PROJECT: ADCNR KAYAK SHELTERS
GMC PROJECT NO. AMOB240054

ADDENDUM NUMBER 3

August 7, 2025

AD3-1 CLARIFICATIONS / RFI'S / RESPONSES:

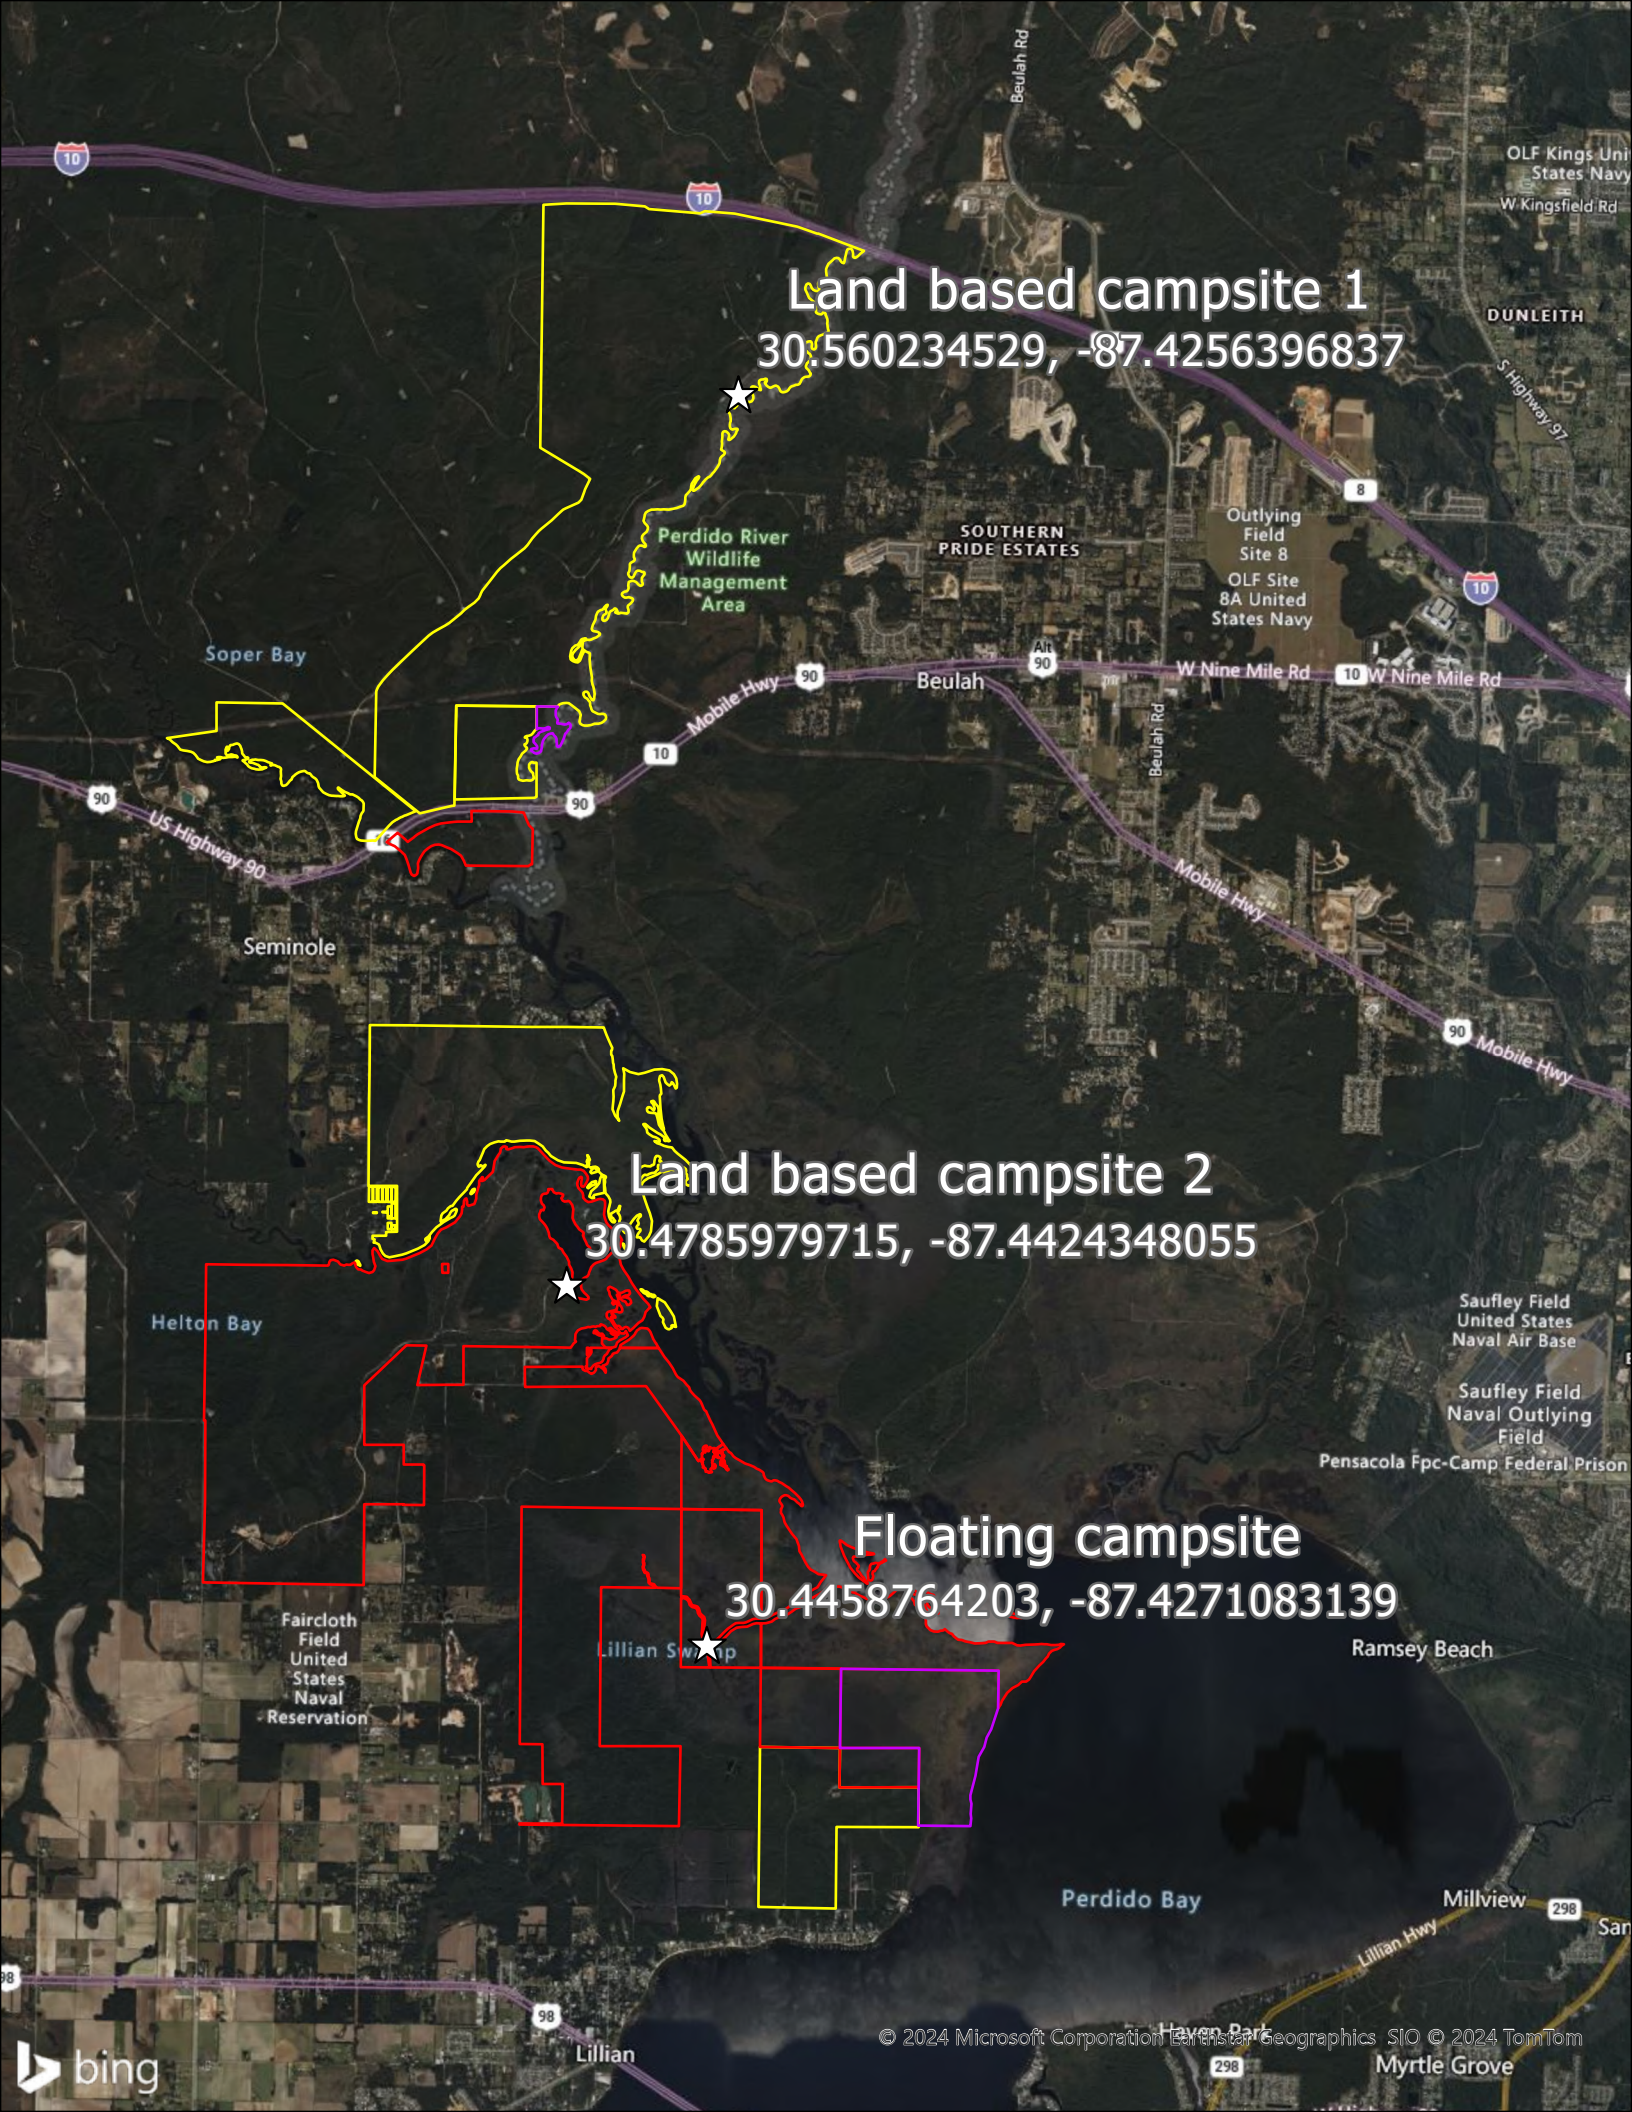
- D. This is a request for GPS readings for all Shelter locations on the Project.
- RESPONSE: See attached map for the Perdido River locations with longitude and latitude as provided by ADCNR. We don't have GPS readings for the shelter locations at Upper Delta. These may not be available until time of pre-construction meeting.**

Land based campsite 1
30.560234529, -87.4256396837

Land based campsite 2
30.4785979715, -87.4424348055

Floating campsite
30.4458764203, -87.4271083139
